Wollongong Local Planning Panel Assessment Report | 27 August 2024

WLPP No.	Item No. 1
DA No.	DA-2022/1113
Proposal	Demolition of existing structures and construction of mixed use shop top housing, three (3) commercial spaces, 36 residential apartments, basement and ground floor parking, communal open spaces, landscaping and stormwater works
Property	68-74 Princes Highway, Fairy Meadow - Part Lot X DP 158631 7 Daisy Street, Fairy Meadow - Lot Y DP 158631 9 Daisy Street, Fairy Meadow - Lot 172 DP 1115076
Applicant	ADM Projects (Australia) Pty Ltd
Responsible Team	Development Assessment and Certification - City Centre Major Development Team (AS)
Acceptance (lodgement) date	13 October 2022
Prior WLPP meeting	None

ASSESSMENT REPORT AND RECOMMENDATION

GROUND FLOOR PLAN

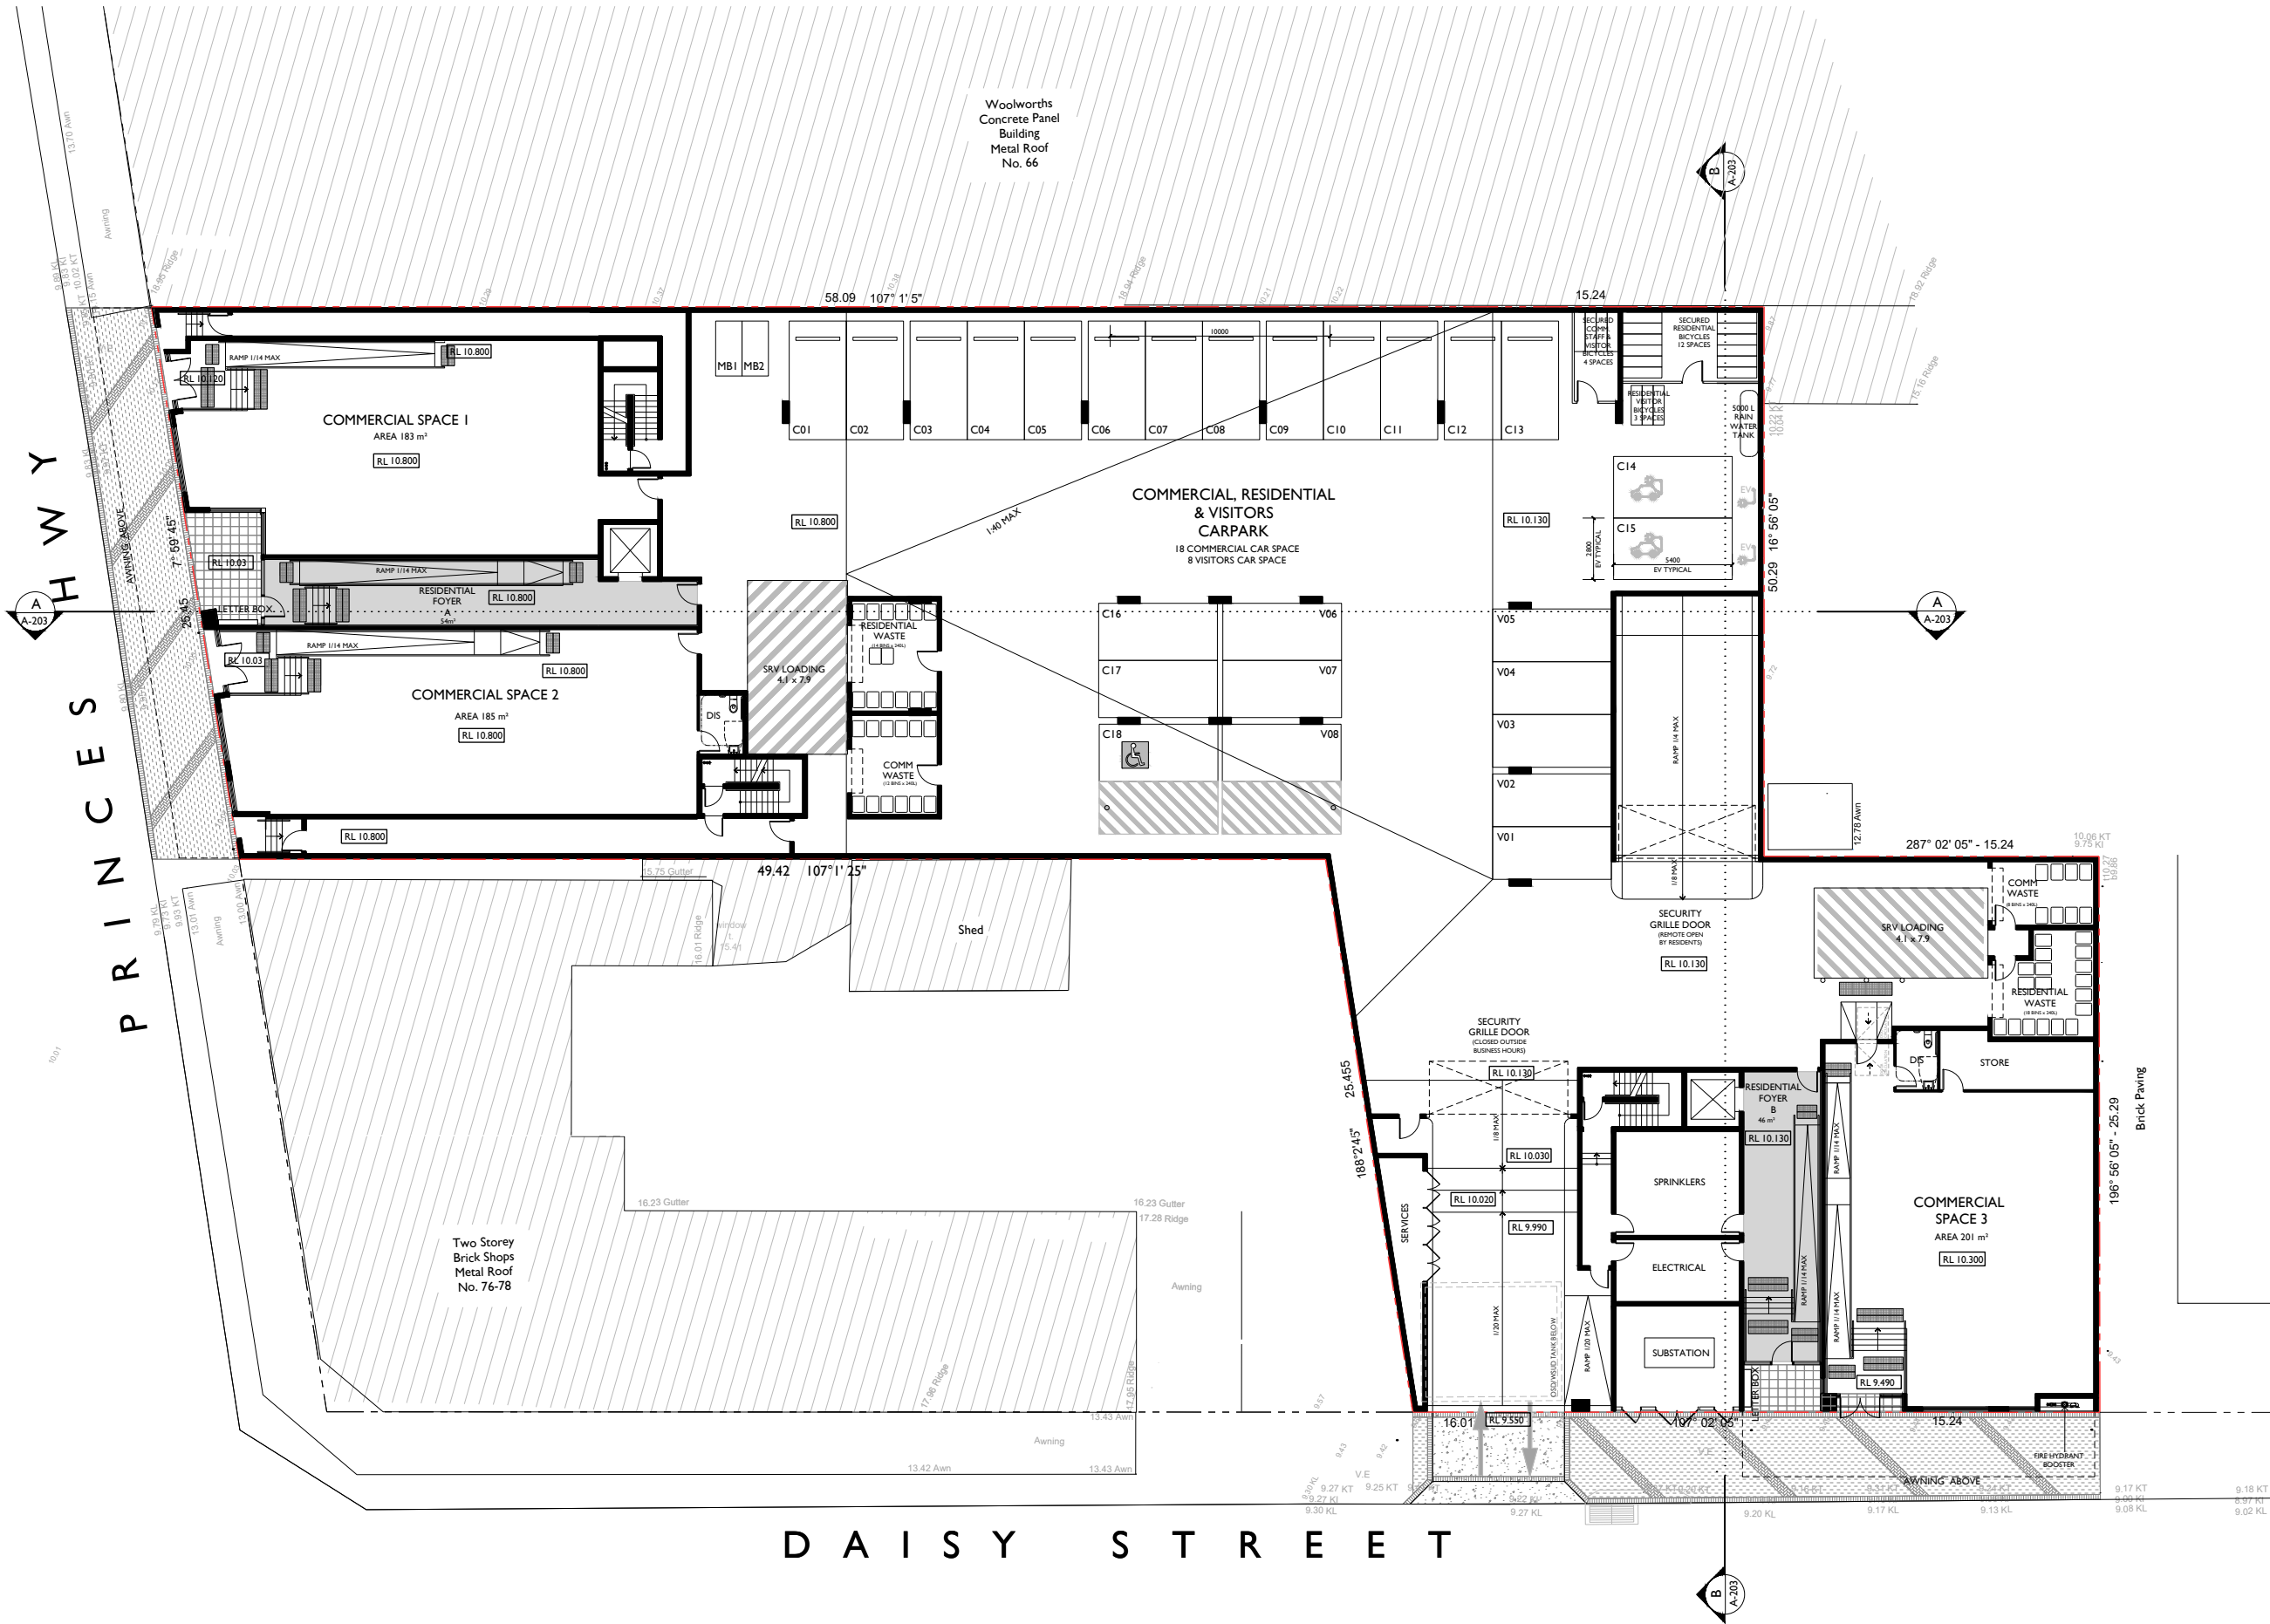
Revised ground floor plan Rev F raising the RL of commercial space 3 was provided on 8 August 2024. This plan now proposes a satisfactory minimum floor level of RL10.30 for Building B and RL10.80 for Building A. Earlier plans proposed lower floor levels which necessitated installation of a flood barrier, however the latest increased floor levels avoid the need of a flood barrier. Council's stormwater engineer has recommended conditions of consent.
